PLAN-020187

Proposal: Ground & first floor rear extensions.

Site: Park Cottage, London Road, Fontwell, BN18 0SG.

WA/66/17/HH

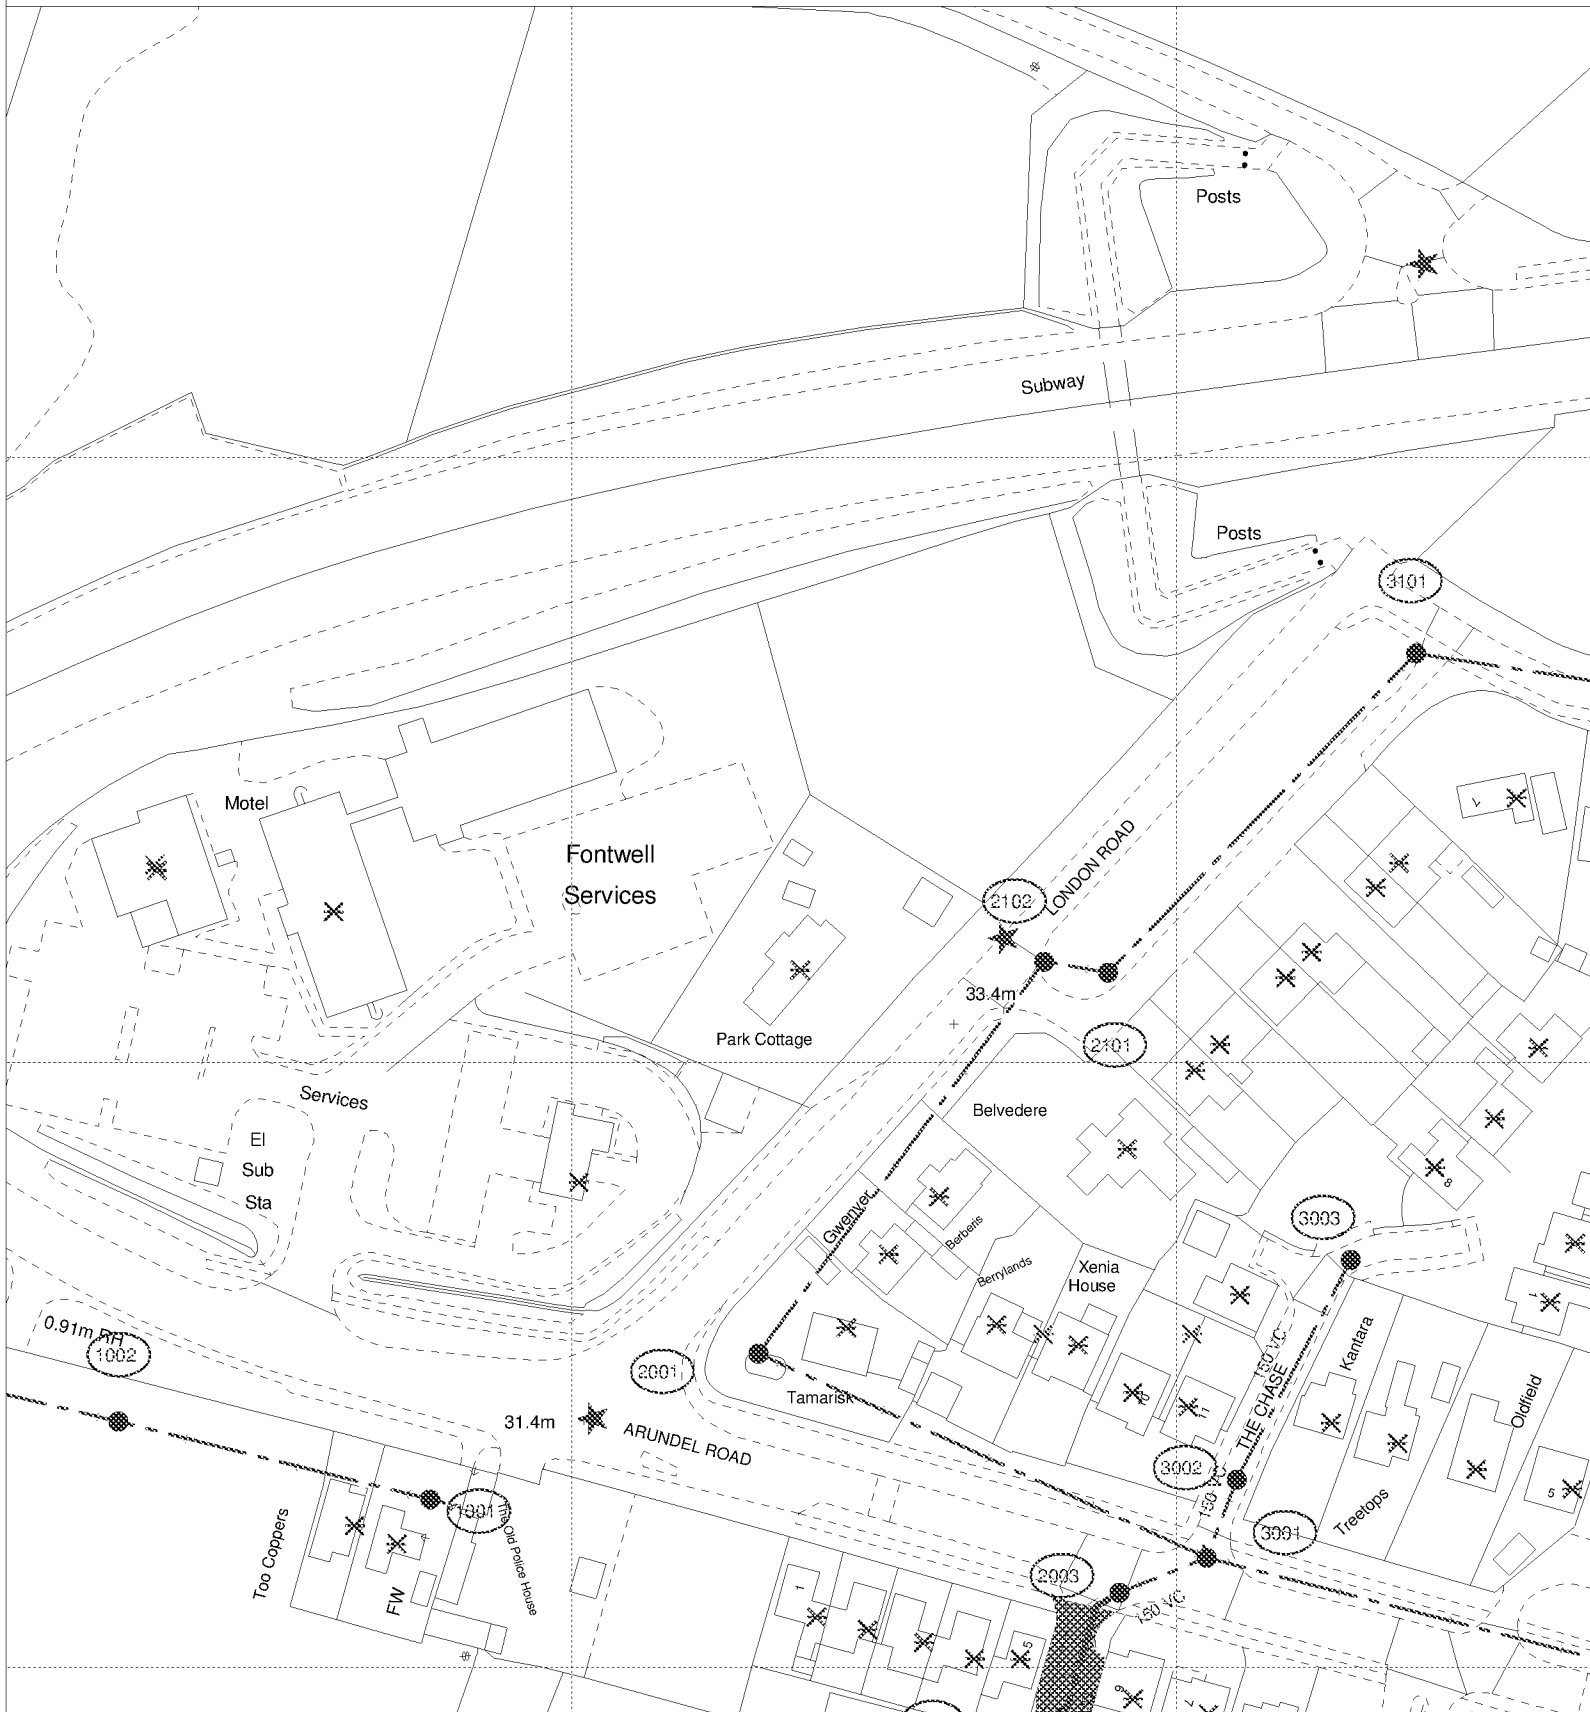
Due to surface water inundation issues in the Lidsey Catchment "The applicant is advised to adopt, where appropriate, the measures in the table "Practical measures to reduce the potential impacts of development".

Developer should look to protect the public sewerage system from inundation and infiltration, which contribute to flooding in unfavourable conditions.
